# SERVICE BULLETIN INDEX

LOTUS CARS Ltd NORWICH NORFOLK NR92W

## 1974 SERIES (FEDERAL)

FIRST GEAR ENGAGED.

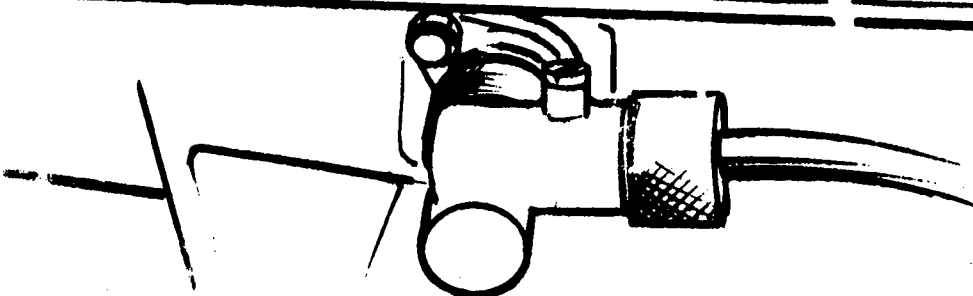
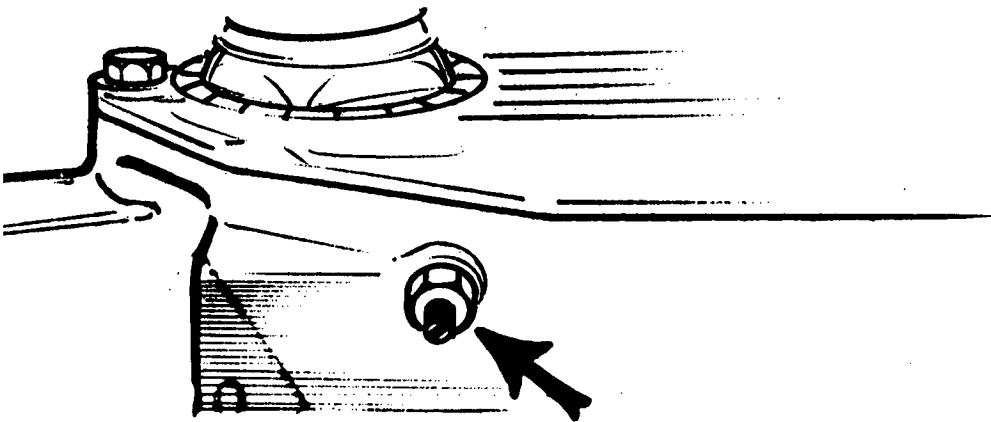
**Title:** Gear Lever Stop Adjustment.

**Reason:** To avoid possibility of dis-engagement between the gear selector link and the selector rod assembly, when fitting a new gear lever.

1. Select 1st gear, noting there is free play at EACH SIDE of gear lever. With the lever at its mid-position (side-to-side), but still in gear, screw in the stop adjusting screw (marked with arrow on illustration), until the gear lever is JUST BEGINNING TO MOVE. The side-to-side movement at the top of the lever MUST NOT EXCEED 4 mm (adjust as necessary), then tighten the locknut. Select all gears to ensure correct operation of gear selector mechanism.
2. Please amend paragraph '7' on page of Section 'F' (Gearbox) of the recently issued Preliminary Workshop Manual, to include this TOTAL MOVEMENT of 4 mm.

CUTAWAY SECTION SHOWING CLUTCH CABLE  
INSULATOR BUSH ASSEMBLY

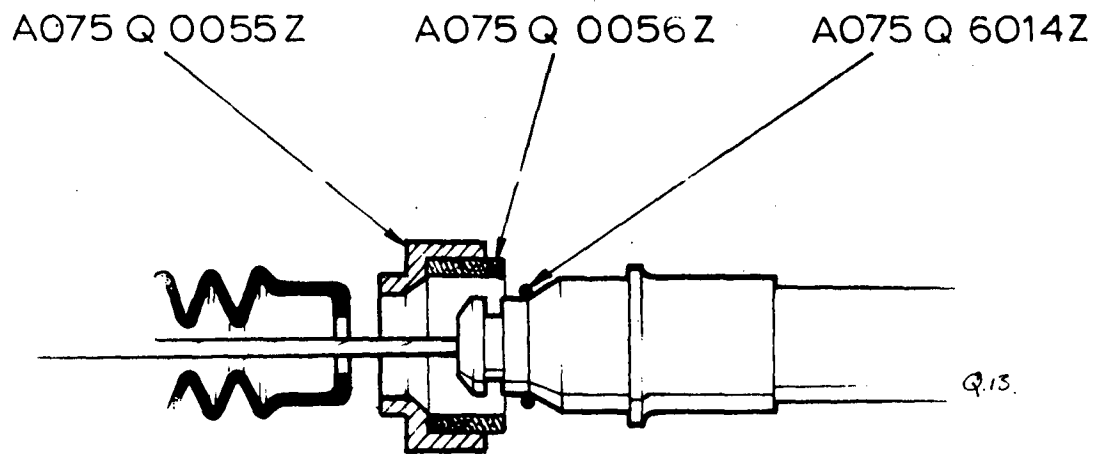
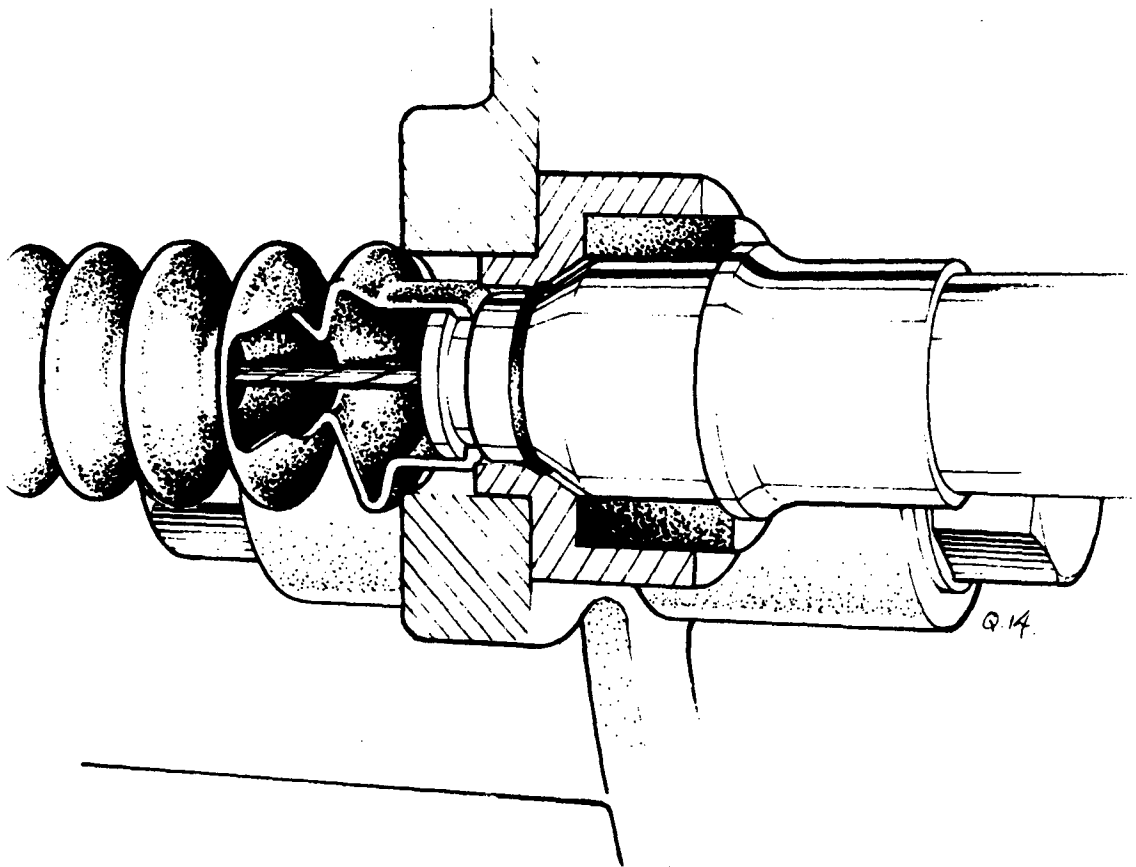
Title: Clutch Cable Insulator Bush Assembly

Reason: To reduce general engine and transmission noise which may be transmitted into the car, via the clutch cable.

1. Remove the clutch cable from its abutment on the bell housing (see Section 'Q' in the Workshop Manual).
2. Fit the insulator (Part No. A075 Q 0056Z) to the adaptor (A075 Q 0055Z).

3. Fit the 'O' ring (Part No. A075 Q 6014Z) to the clutch cable sleeve, adjacent to its tapered shoulder, and fit insulator assembly to the outer sleeve of the cable (see illustration).

ANTI-ROLL BAR MOUNTING (RH ILLUSTRATED)

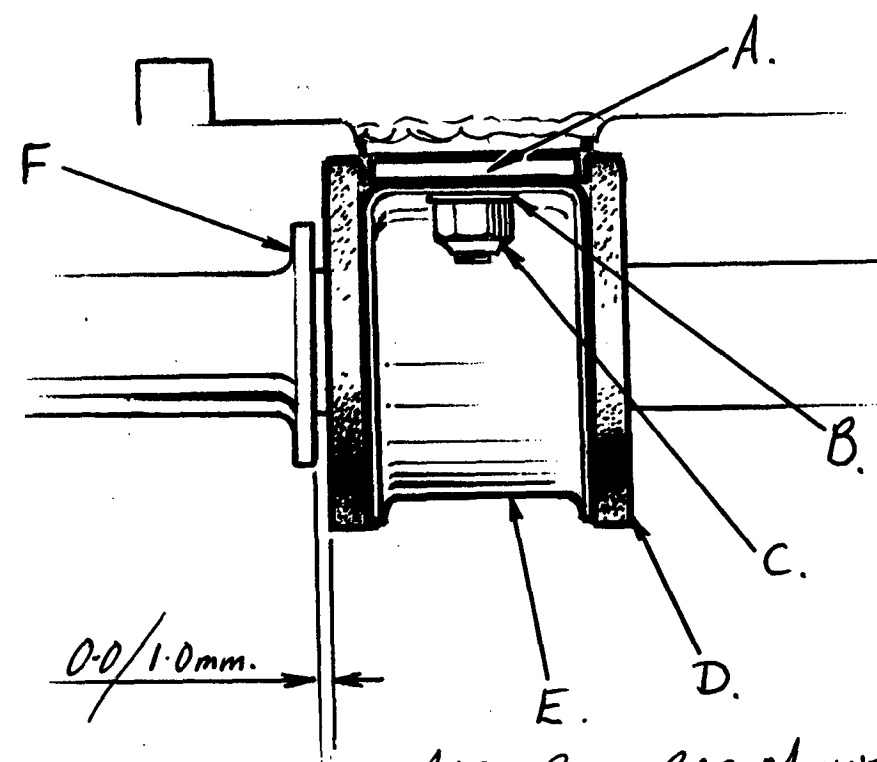
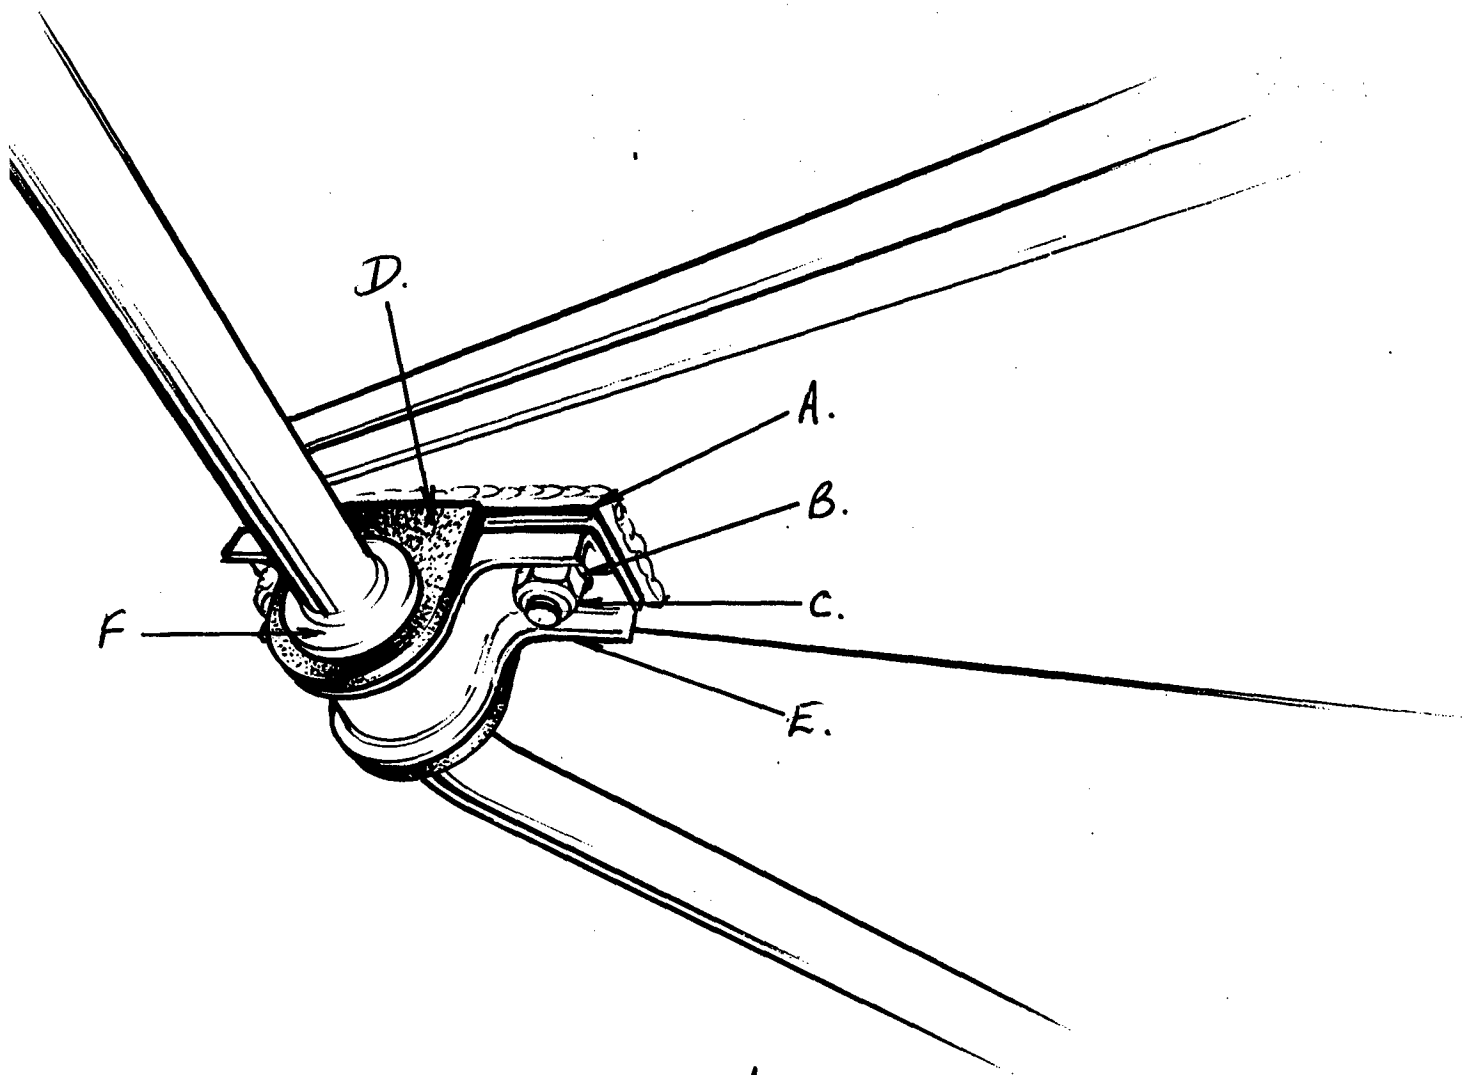
Title: Anti-Roll Bar.

Reason: Improvement to fixing specification.

Action: Where the anti-roll bar mounting (securing the anti-roll bar to the chassis) rubber bushes, are attempting to 'work out' from their fitted location, the following action is recommended:

1. Remove the existing 'U' brackets and fit the new 'U' brackets (Part No. A075 C 0148K), but with the additional plate (Part No. A075 C 0147K) BETWEEN the bush/bracket and the chassis.
2. Before fitting the securing bolts, ENSURE the washers (Part No. A075 W 4024Z) are fitted beneath head of bolts and the 'U' brackets.
3. Brackets should be bolted in position so that the dimension between abutment on the anti-roll bar and the rubber bushes is, Zero (just touching) to 1 mm. clear MAXIMUM, with the wheels in the straight-ahead position.

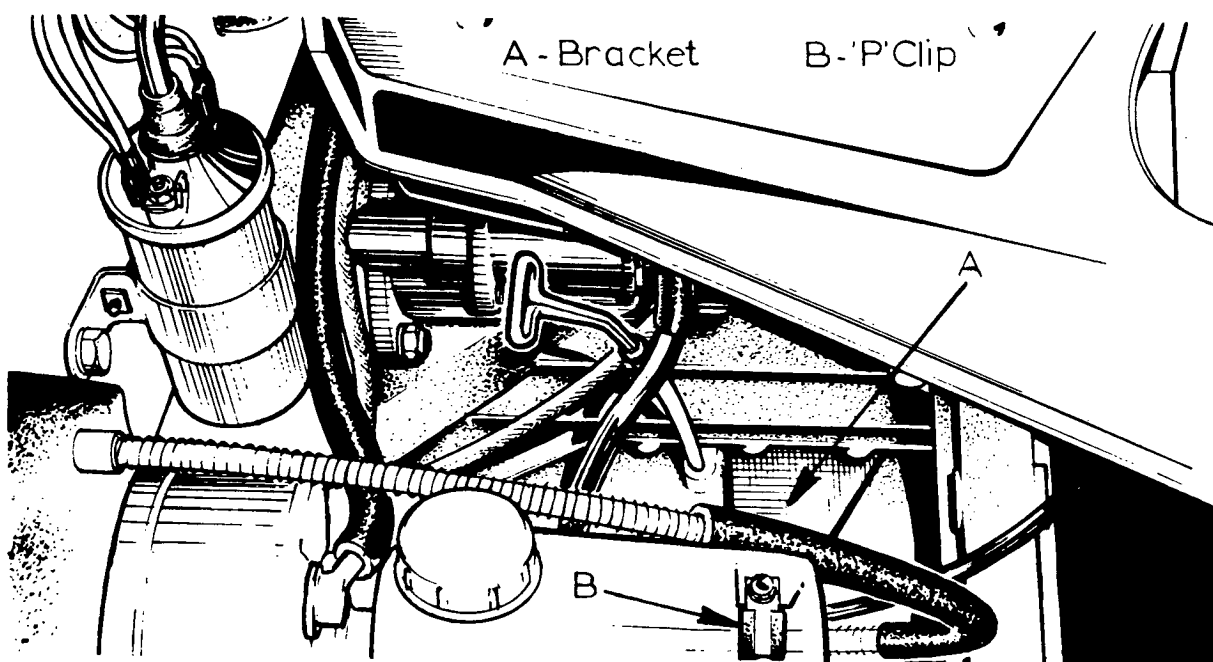
Title: Clutch Cable (R.H.D. only)

Reason: Correct location of cable.

1. Using the illustration as a guide, attach the steady bracket to the engine.  
The bracket is mounted on the first pair of sump studs rearward from the front of the engine, with its square edge rearward on the right hand side.
2. Secure the cable with the 'P' clip, and attach clip to bracket with the screw and nut.

Fig. 1.

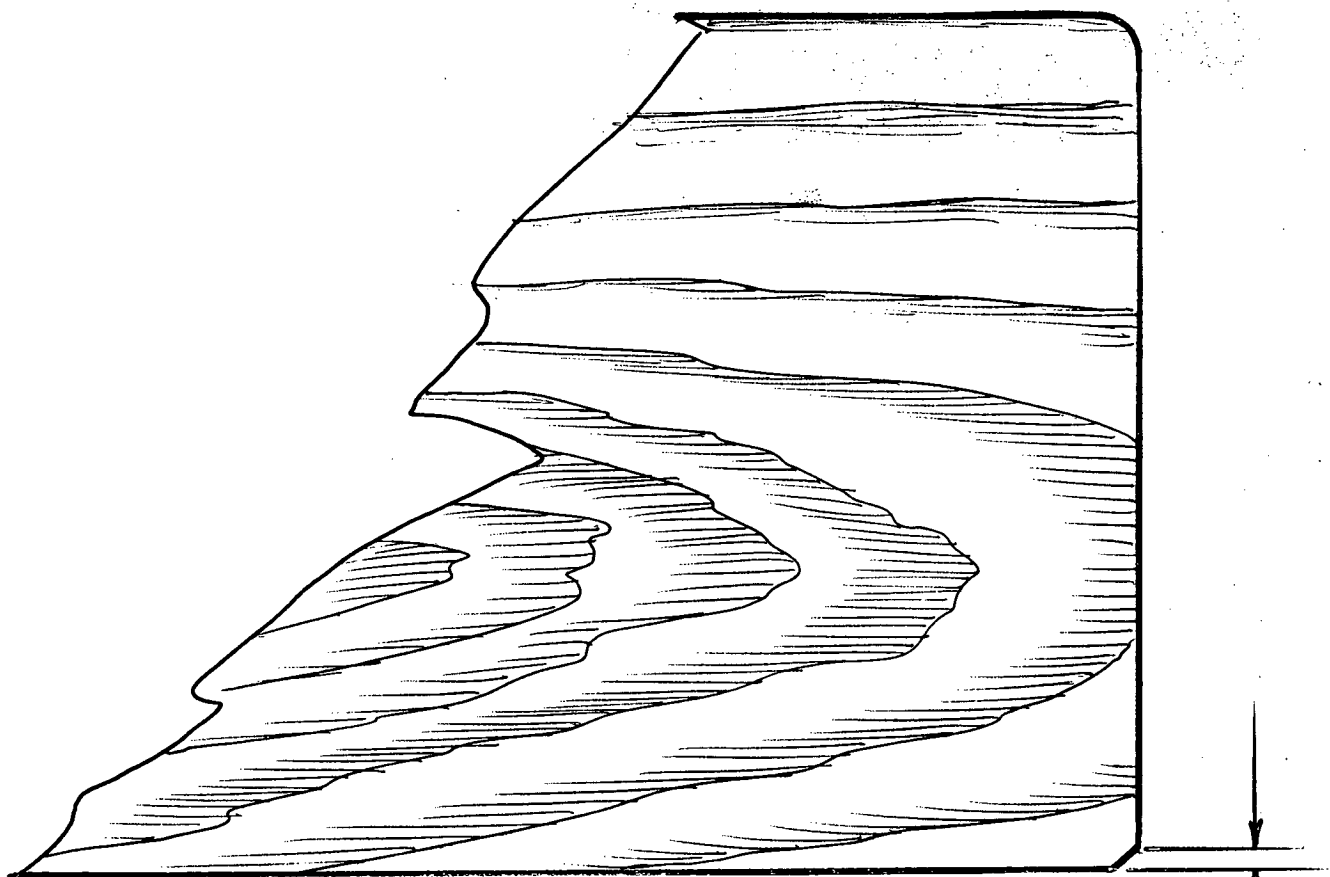
Title: Glove Box Door Finisher

- Action:
1. Using the illustration Fig. 1 as a guide, file the lower corners of the door to the shape indicated.
  2. If the finisher is fitted with tags, these should be carefully removed. Place a single strip of adhesive into the finisher section, pinching it slightly as shown on illustration, Fig. 2, to avoid excess adhesive being extruded as the finisher is fitted.
  3. Place the finisher in position centrally over the door, then press into position, using finger pressure only, all in one operation, as once fitted, difficulties will be experienced in moving the finisher without it being damaged.

REMOVE LOWER CORNERS  $3.5\text{mm} \times 45^\circ$

Fig. 1.

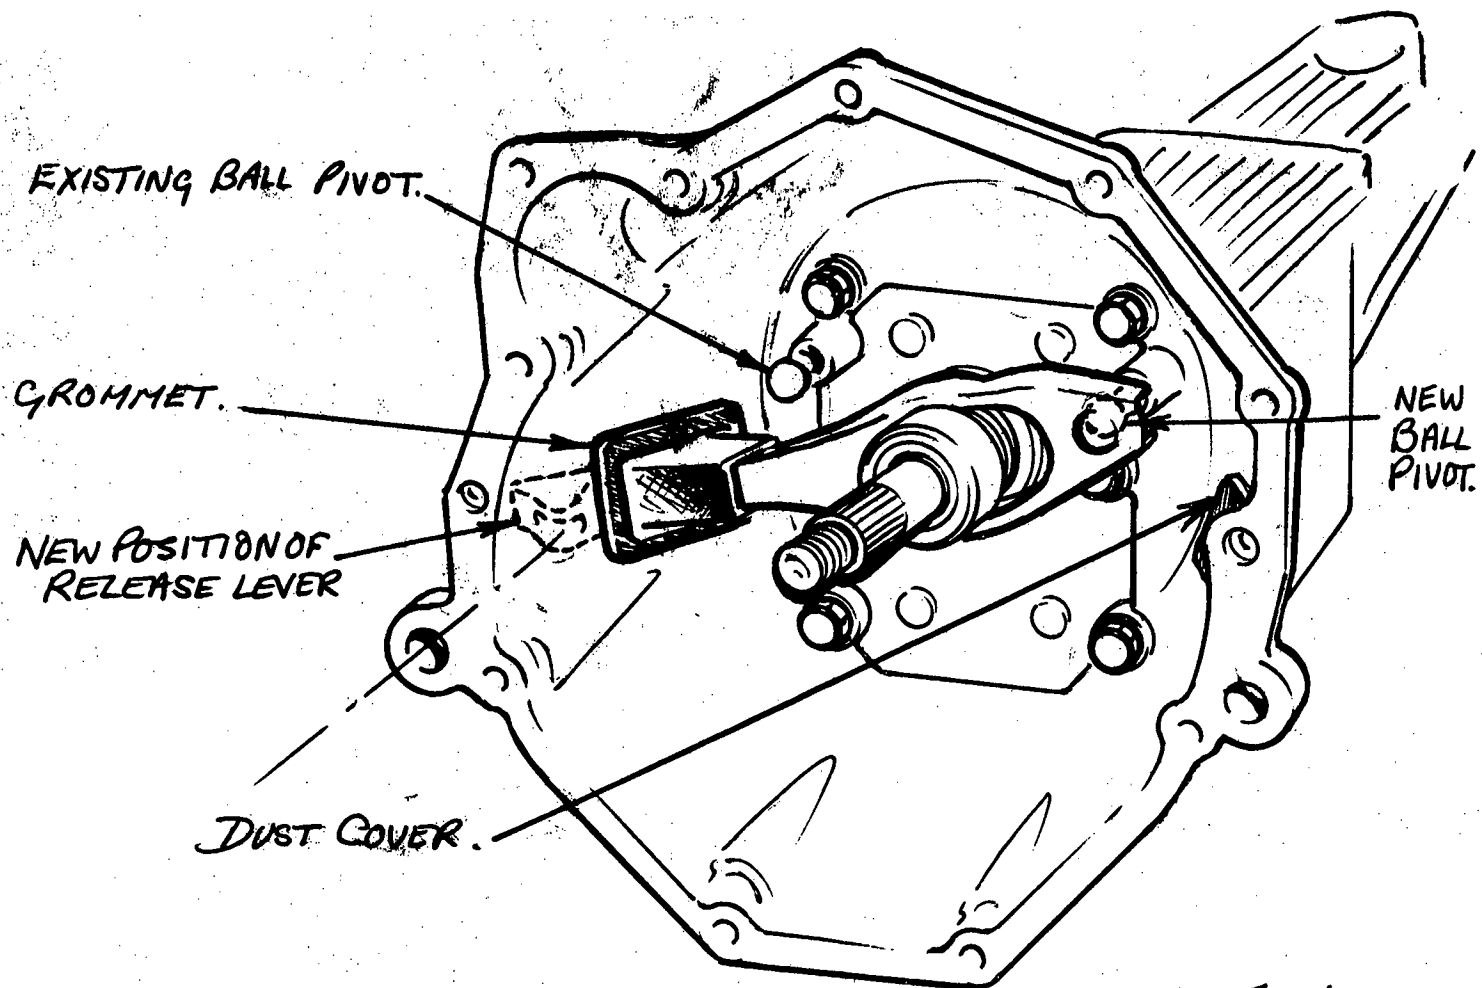
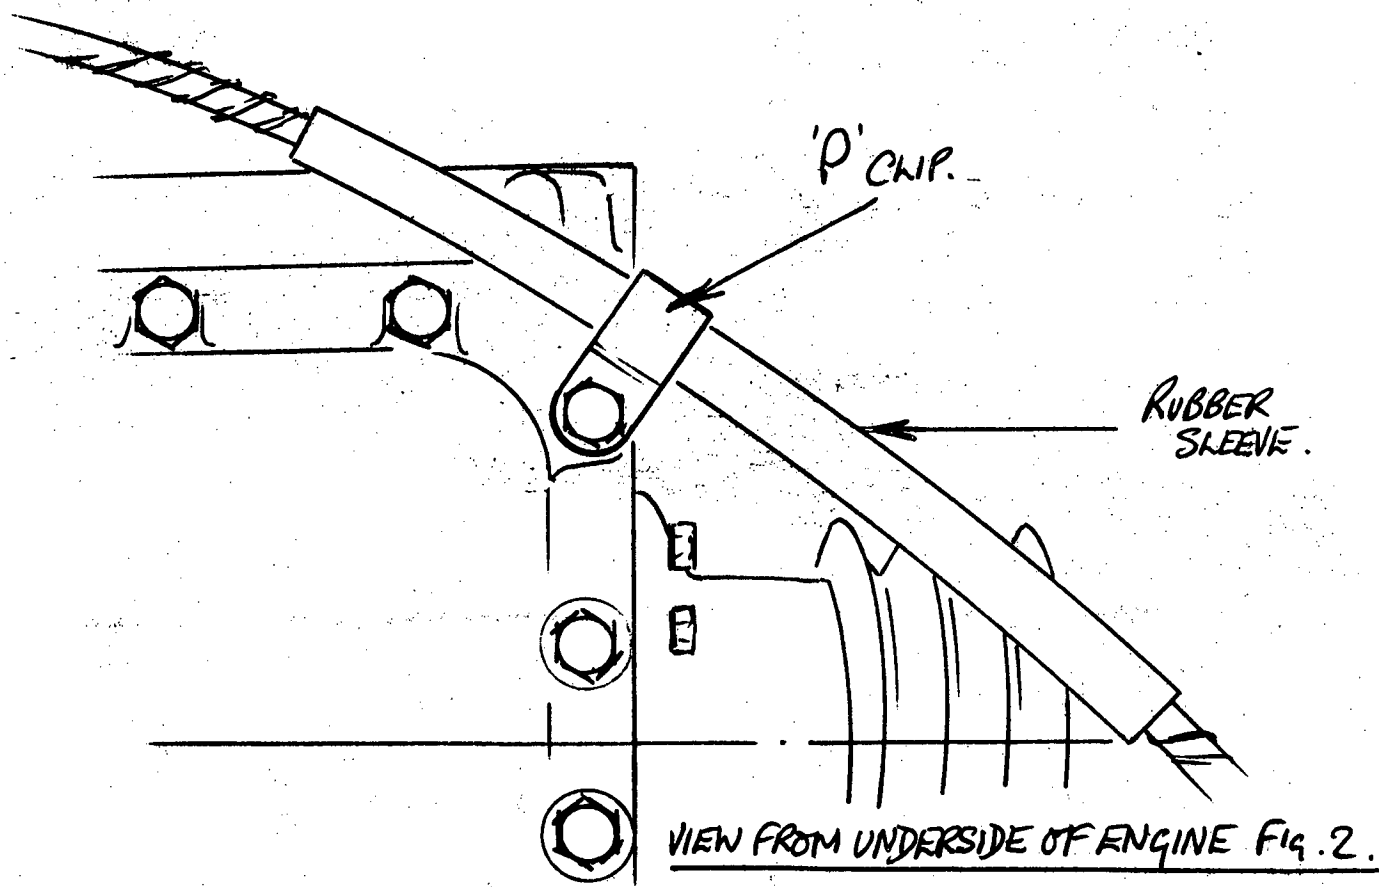
**Title:** Change of clutch cable and clutch release mechanism to operate from right hand side of clutch housing.

**Reason:** To eliminate the possibility of clutch cable seizure on left hand drive cars.

**Action:** Remove the engine/gearbox assembly (Section E26).  
Remove the existing clutch cable (Section Q3) and discard the cable.  
Part the gearbox from the engine at the bell housing.  
Remove the clutch release lever and the release bearing.  
Remove the dust cover from the RH side of the bell housing and fit the dust cover to the LH side. Leave the existing pivot for the clutch release lever in the bell housing.  
Apply loctite RC 35 to the lower part of the additional pivot Part Number A075 Q 6010Z and fit it to the LH side in the bell housing. Fit the clutch release bearing and the clutch release lever with its grommet so that the clutch release lever is protruding from the RH side of the bell housing. See Fig.1.  
Fit the gearbox to the engine. Replace engine and gearbox assembly. Fit the new (longer) clutch cable Part Number B075 Q 0051W, and route the cable to the RH side of the bell housing. The Two rubber sleeves on the clutch cable are positioned to provide insulation against the body and the steering unit. Secure the cable with cable strap Part Number A075 W 6038Z to the metal part of the heater/pipe to prevent cable movement and possible fouling of the crankshaft 'V' pulley.

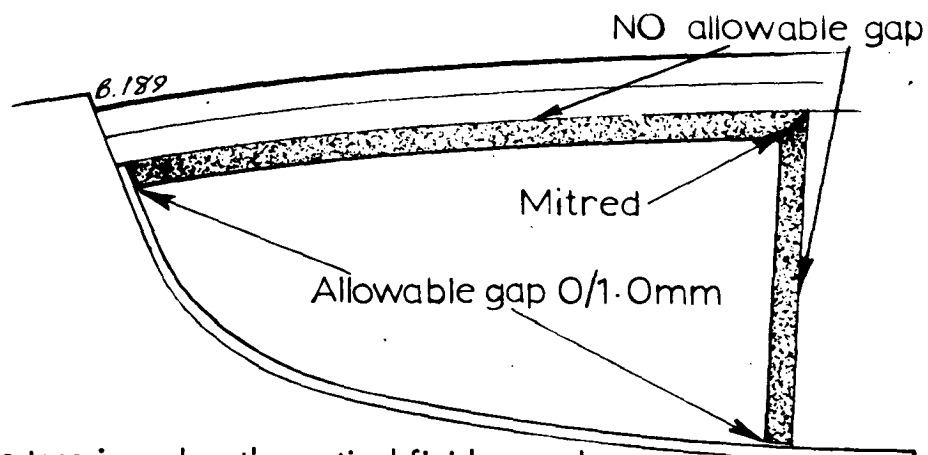
Title: A.B.S. (Plastic) exterior rear quarter light finishers.

Reason: Improved specification altering the assembly procedure.

- Action:
1. Place the finishers on the glass and trim them as necessary to achieve correct fitting dimensions. See illustration. Remove the finishers.
  2. Clean the mating faces on the glass and on the finishers with a soap type solution, rinse it and dry with paper towelling.
  3. Apply the adhesive tape to the finisher. Care should be taken not to stretch the adhesive tape. Do not remove the backing tape until the last moment prior to fitting the finisher.
  4. Place the finisher on the glass, but do not apply any pressure until the finisher is satisfactorily located. Having achieved a satisfactory assembly apply heavy pressure for a short period. Finally clean the rear quarter light glass of any finger marks etc.
